ELMIRA NORTH - SITE PLAN WITH ADJUSTMENT

ELMIRA NORTH - SITE PLAN
WITH ADJUSTMENT
2525 N. ELMIRA STREET AURORA, CO 80010

SITE PLAN

2 NORTH ELEVATION
3/16" = 1'-0"

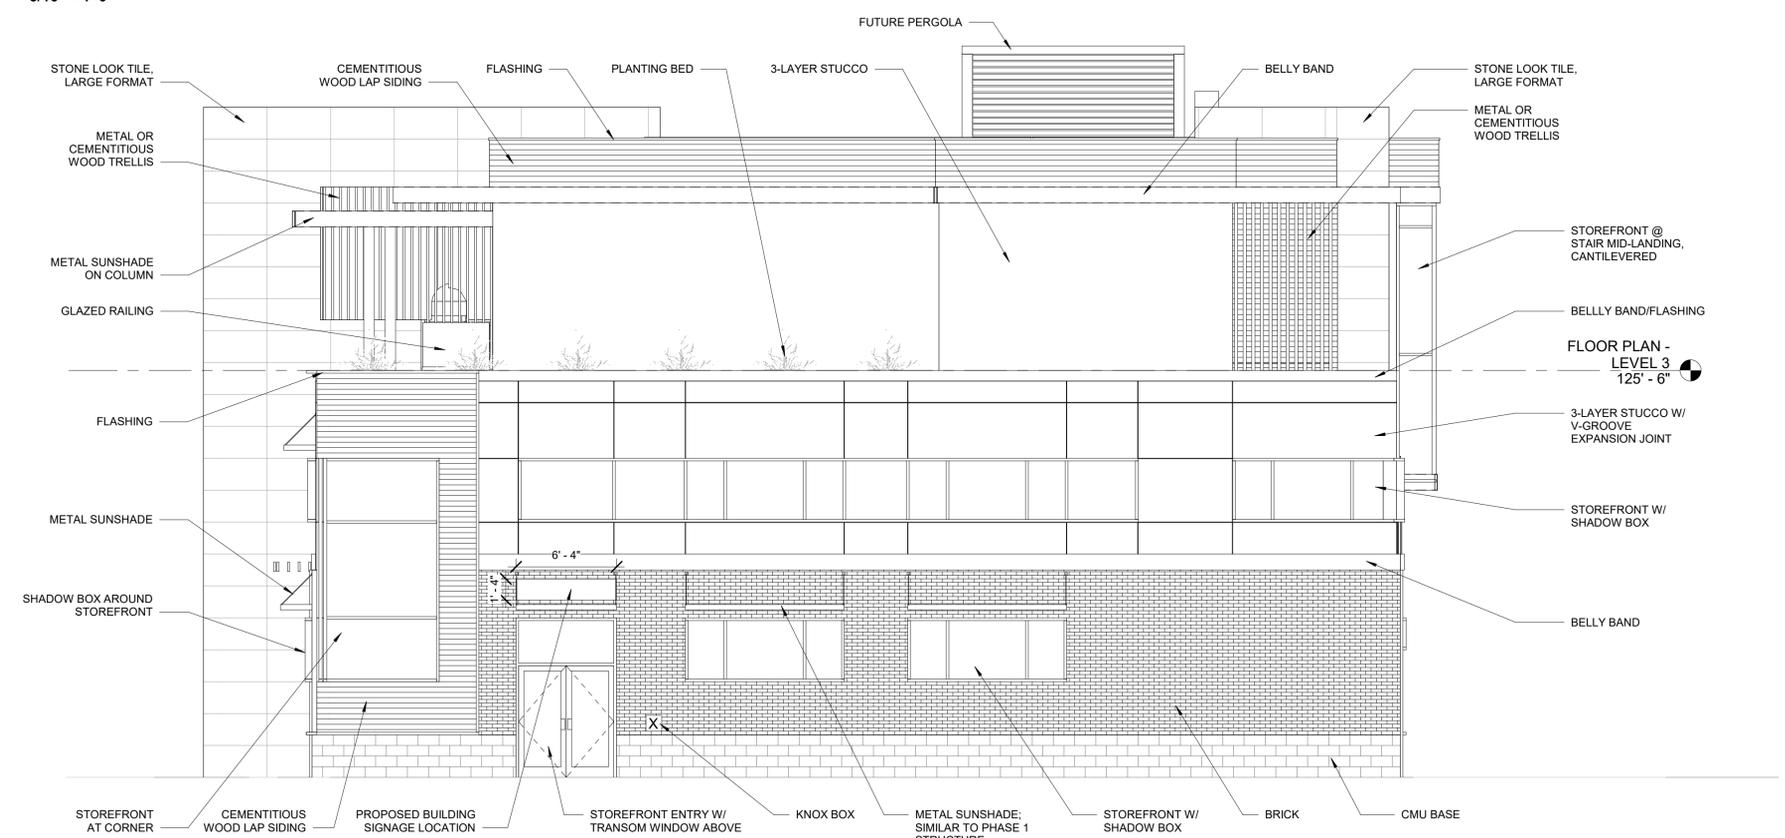
Please add these percentages and square feet totals to the Coversheet Data Block as well.

FACTOR RESPONSE: BUILDING ELEVATION MATERIALS HAVE BEEN ADDED TO COVER PAGE DATA BLOCK. NOTE: UPDATED MATERIAL CALCS HAVE ALSO BEEN INCLUDED.
